# Access Compliance Report

## Public Rights-of-Way

### (Pedestrian Signals)

Intersection ID: N/A	Main Street:	Cross Street: N/A	Location: N/A
ADA ID: ABA443C4B1CB	Signal Type: One Push Button-Non APS	Overall Compliance: No	Severity Score: BTN 1: N/A BTN 2: N/A No BTN: N/A
Codes/Mitigation Info/Possible Solution		Field Measurements/Component Compliance

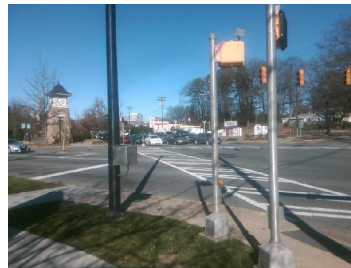
Possible Solutions: Replace Signal Push Button With APS Button on New Post. Remove & Relocate Sign.

PROW/ADA: , TMUTCD 4e.08, R404.2, R406.2
